South Texas Project Electric Generating Station P.O. Box 289 Wadsworth, Texas 77483

December 21, 2010  
U7-C-STP-NRC-100274

South Texas Project  
Units 3 and 4  
Docket Nos. 52-012 and 52-013  
Supplemental Response to Request for Additional Information

RAI 03.07.01-27, Supplement 1

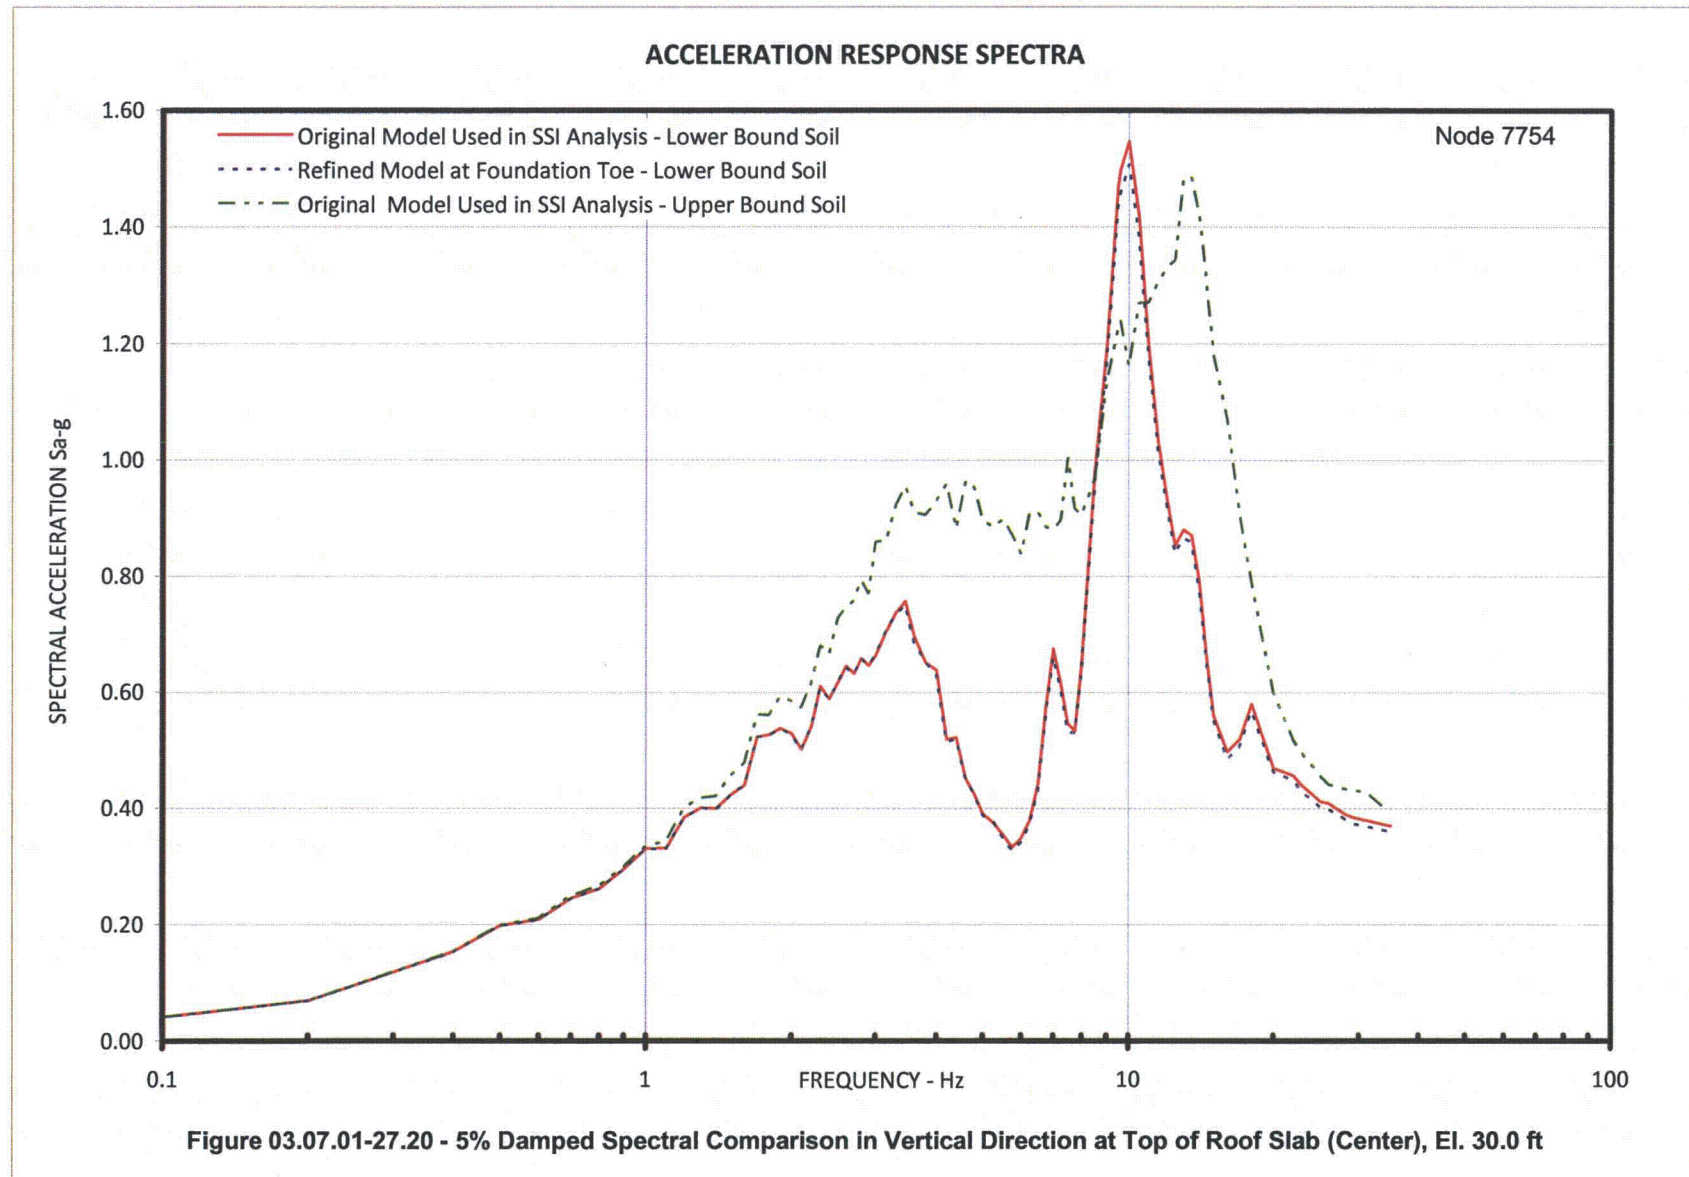
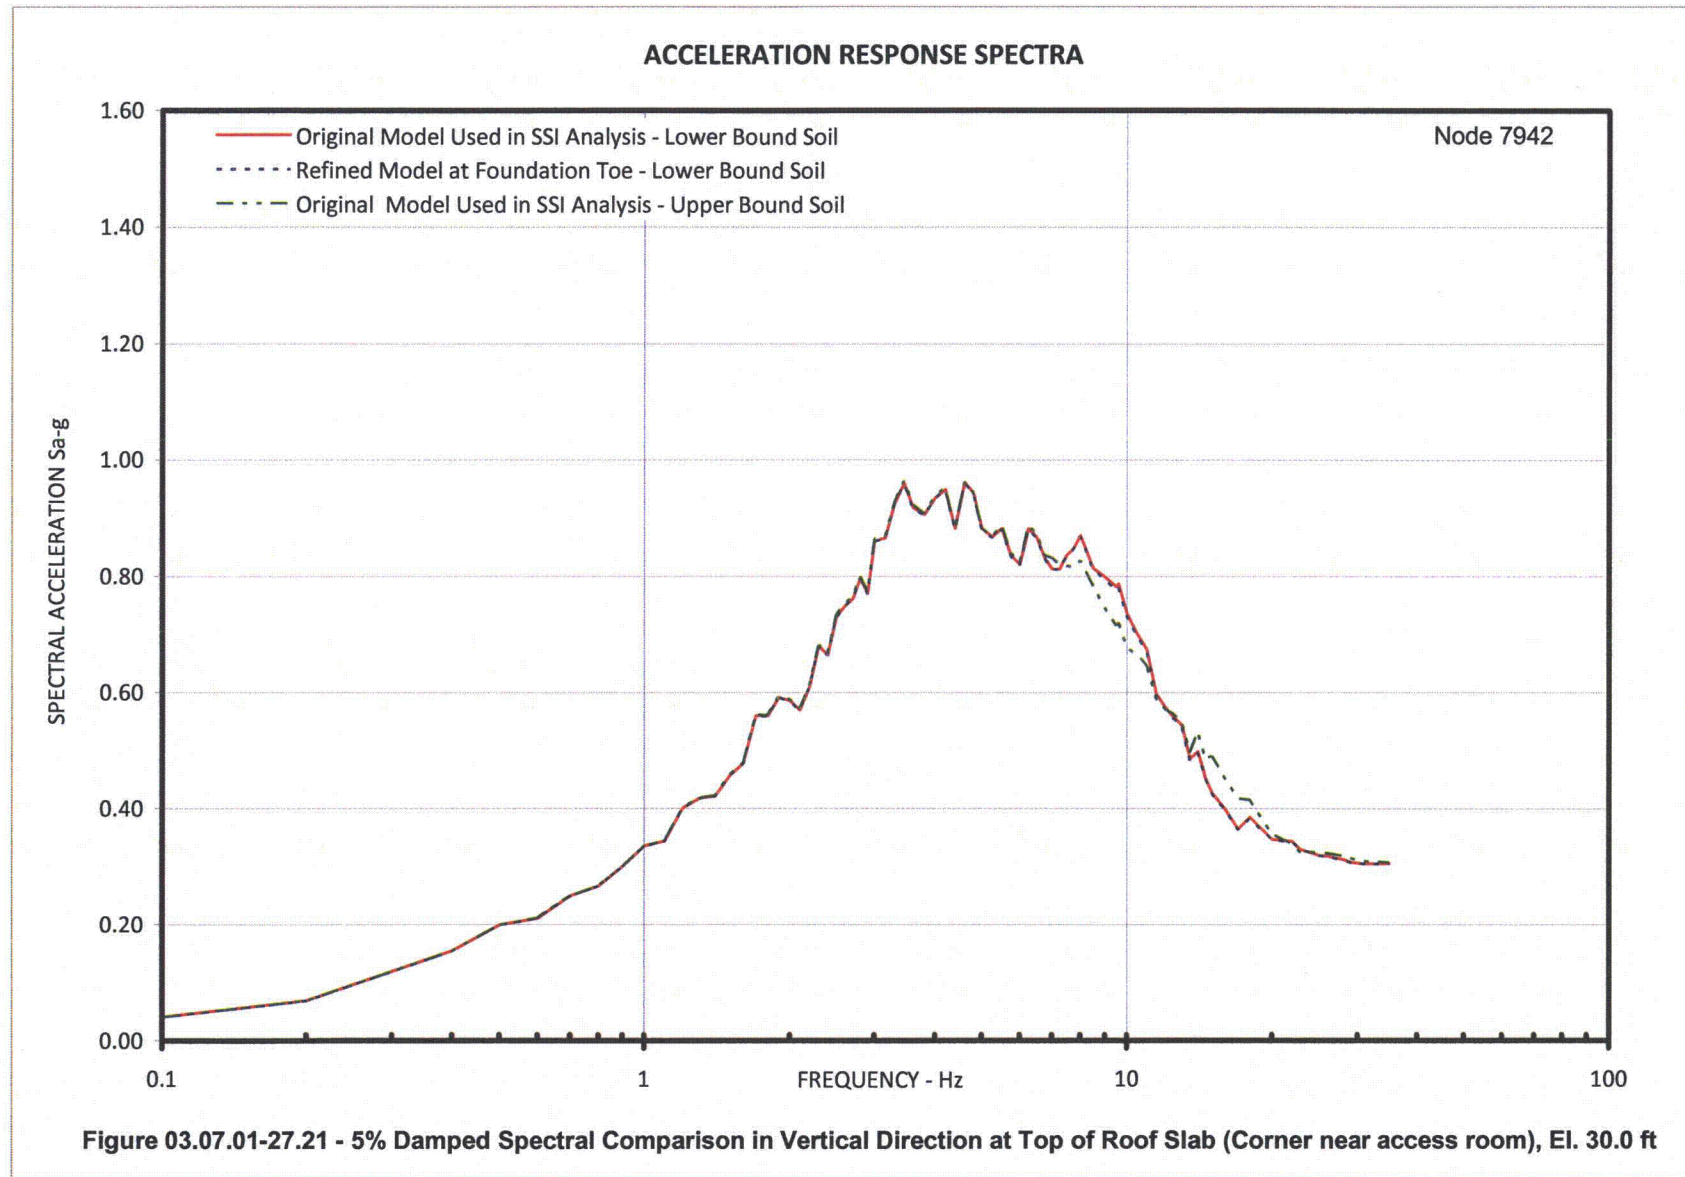
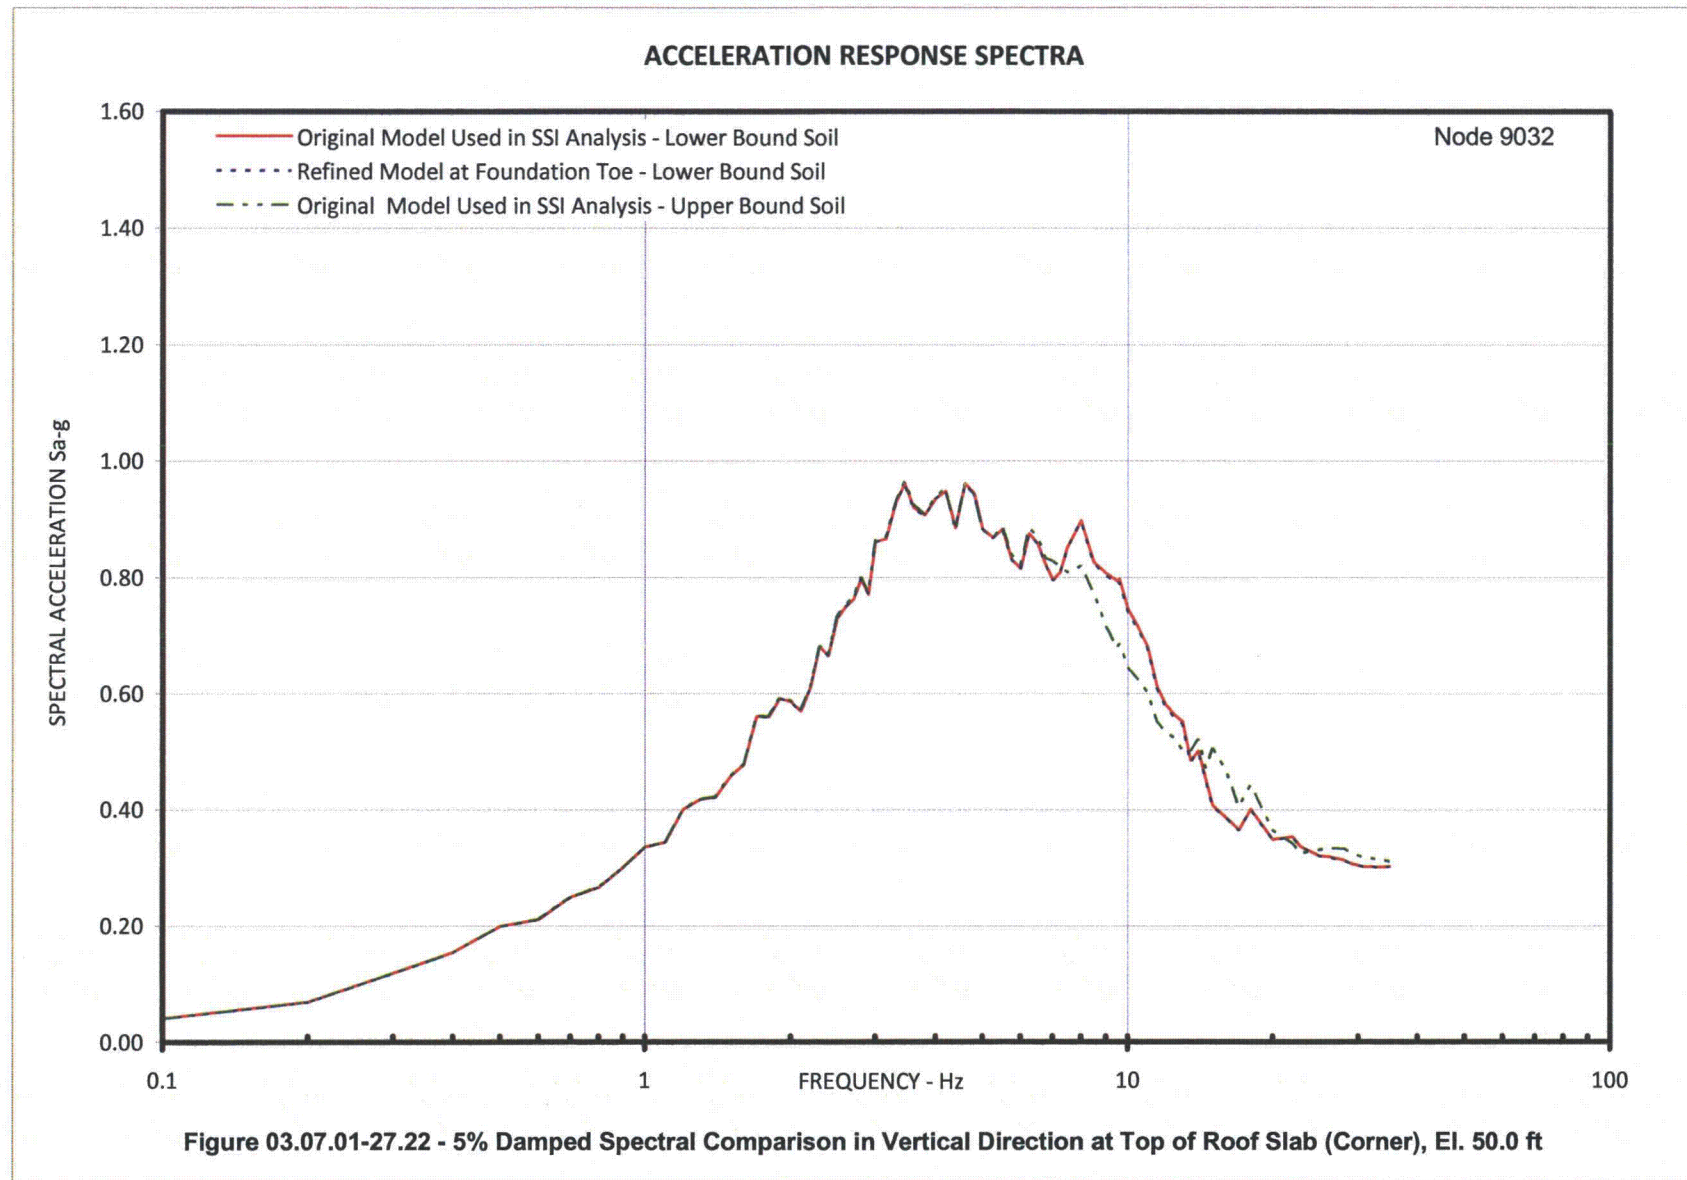
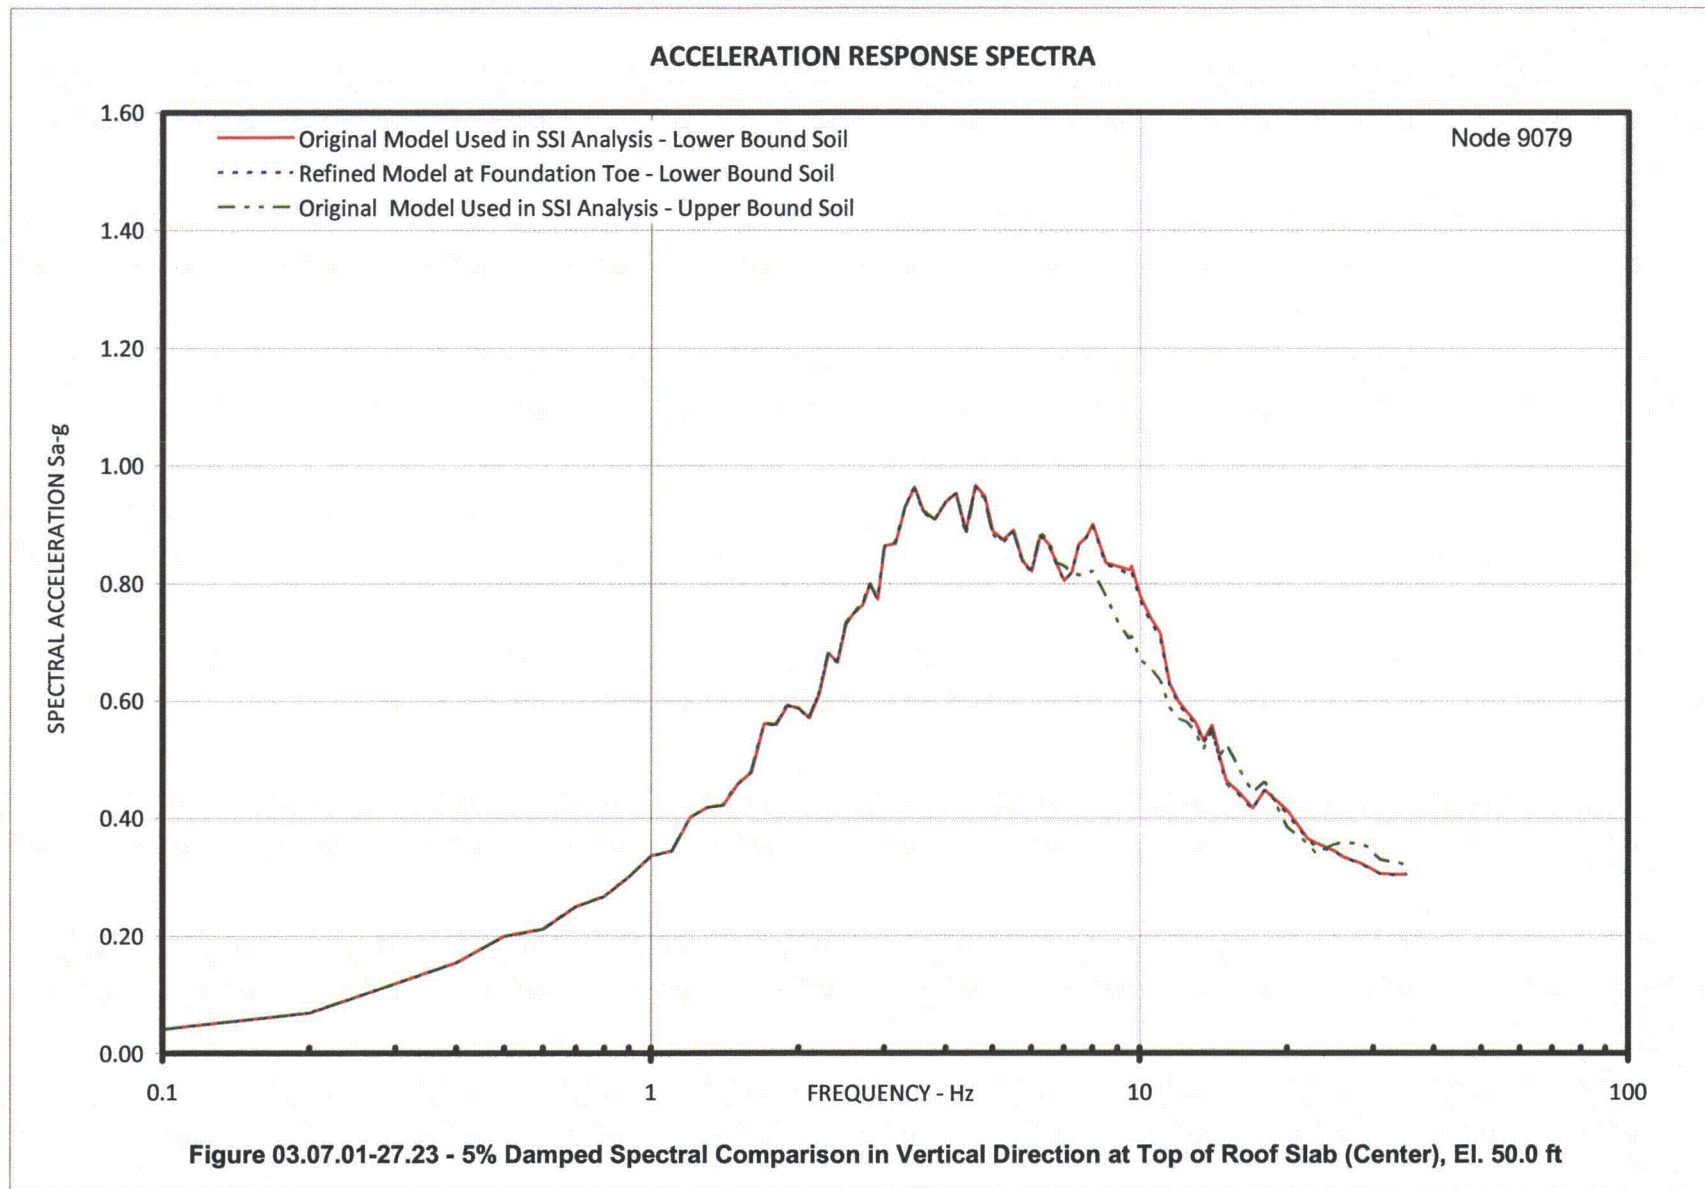
- (a) Describe in detail the method used for the SSI analysis of DGFOVS including the procedures for treatment of strain dependent backfill material properties in the model, input motion used and how it is specified in the analysis, variation of soil properties, and the computer programs used for SSI analysis.

To evaluate the effect of 20 Hz passing frequency for LB in-situ case, the foundation toe was divided into two elements, thus increasing the passing frequency to 40 Hz. This refined model with LB in-situ soil properties was analyzed and 5% damped spectra from this model were compared with the spectra from the original model with passing frequency of 20 Hz. The spectra comparison plots are shown in Figures 03.07.01-27.1 through 03.07.01-27.24. The comparison shows that:

- In the X direction, there is insignificant difference between the response spectra from the two models
- In the Y direction, the response spectra from the two models matched well except at frequency of about 3.8 Hz where the refined model produced higher spectra. However, spectra from both the models are enveloped by the spectra for UB in-situ soil case
- In the vertical direction, the spectra from the two models matched well (insignificant difference)

Based on the above evaluation it is concluded that the horizontal direction passing frequencies are acceptable.
